| Project | IEEE 802.16 Broadband Wireless Access Working Group < http://ieee802.org/16 > | |
| Title | Comments on MS ranging and network entry in transparent and non-transparent mode | |
| Re: | IEEE 802.16j-07/043: "IEEE 802.16 Working Group Working Group Letter Ballot #28" | |
| Abstract | This contribution proposes to correct and merge the paragraphs in MS ranging and network entry in both transparent and non-transparent mode. | |

Figure 117a Handling CDMA ranging code at a non-transparent RS

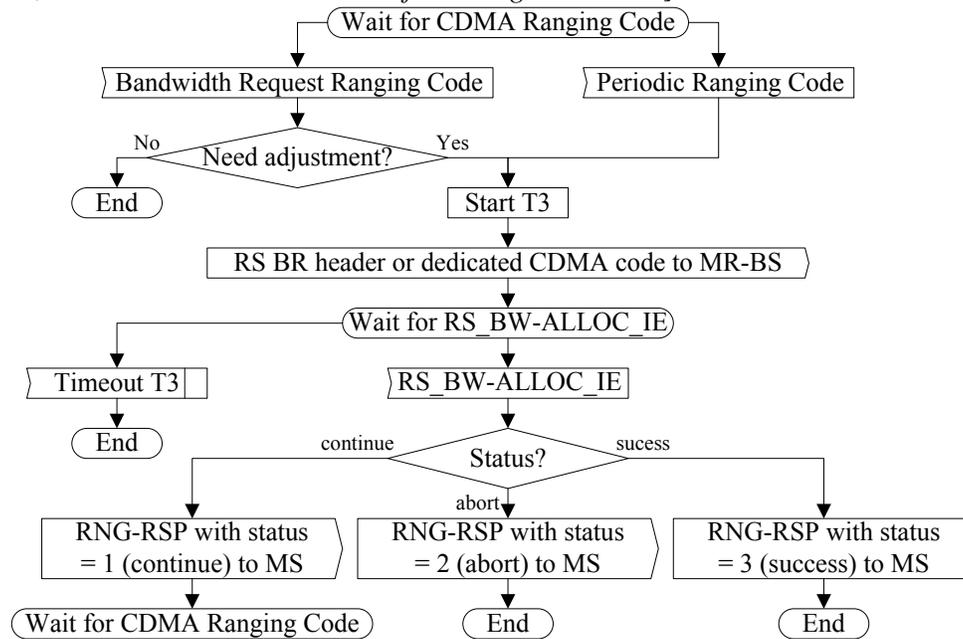
[Merge Figure 108c, and then move it to here as following indicated:]

Figure 117b—MS upstream transmission adjustment at an uplink-only transparent RS

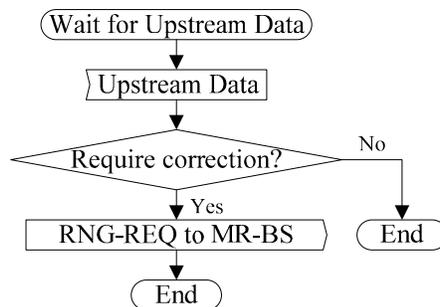
[Move Figure 108f to here, and modify it as following indicated]

Figure 117c—MS upstream transmission adjustment at a RS under centralized scheduling

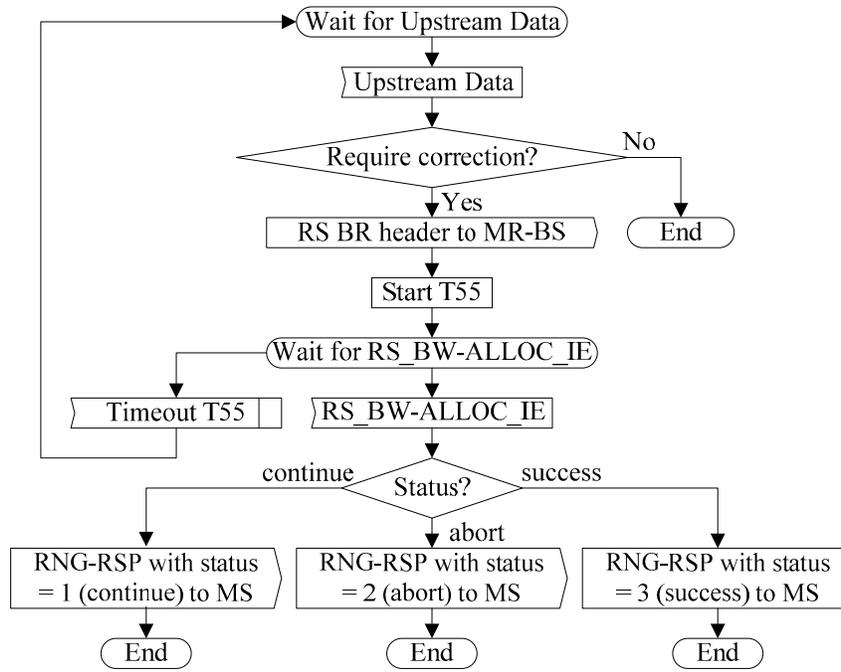
[Merge Figure 108f with Figure 108j, move it to here, and modify it as following indicated]
